TANDBERG TAPE RECORDER INFORMATION

No. 104

Series 3000X/6000X

Modified take-up clutch

Bottom view of take-up turntable and friction disc.

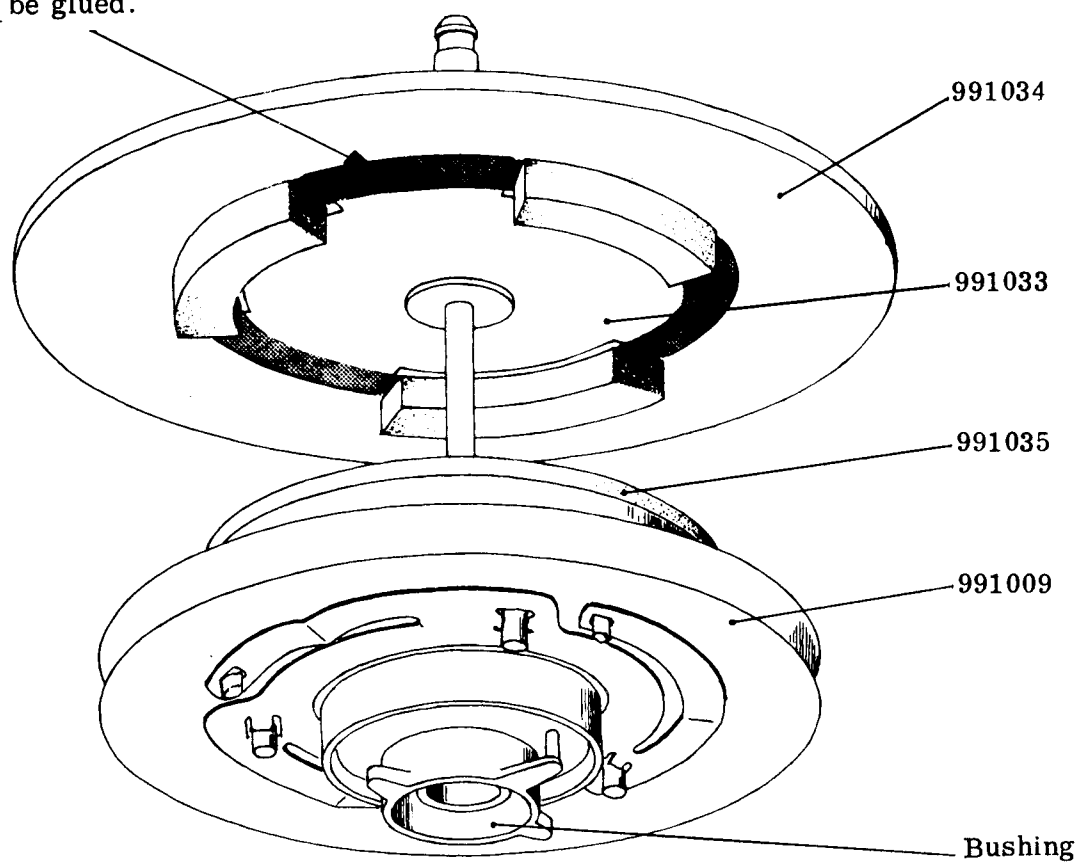
The materials originally used in the take-up clutch have after prolonged operation in hot environments in some cases shown a tendency of excessive wear.

Clutch components in a better material were introduced in production from the following serial numbers:

In some units, the bushing in the friction disc has a wide flap instead of a small stud to prevent rotation. The bushing with the flap can be snapped out of the bearing by means of a screwdriver and must be installed in the new friction disc to facilitate the rest of the assembly

The hatched areas indicate the adhesive coating holding the friction pads. The mylar sheet must not be glued.

The same parts are available as service kits comprising:

1 ea take-up turntable with friction
pads, and mylar sheet with felt

1 ea take-up friction disc with
coupling disc, spring, ball bearing
and bushing
